SCHURTER

1 Products affected

Product Change Notification				SWM nut change second step			
owner	creation date	release date	released by	change order no	rev	page	D10-056-473
zeierjo	08.04.2021	21.09.2021	haeckima	2021508	А	1 of 2

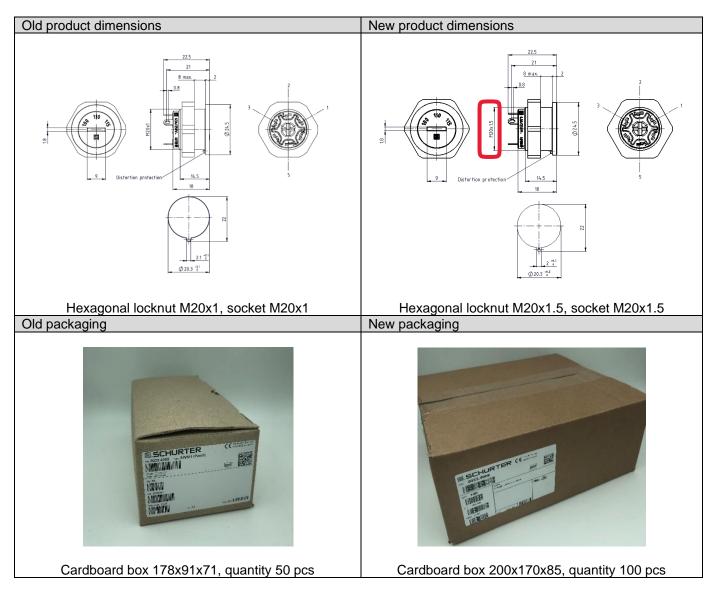
The locknut and the socket of the SWM voltage sector changes to a M20x1.5 thread (previous M20x1).

• The nut was discontinued by our supplier. Additionally, the design was changed to a new nut which can be mounted by hand or by a fork spanner.

Form	Yes	No action needed as the new locknut is shipped together with the new socked.
Fit	No	
Function	No	
Manufacturing	No	
Label	No	
Packaging	Yes	The size of the cardboard box has changed. Consider your logistic implication.
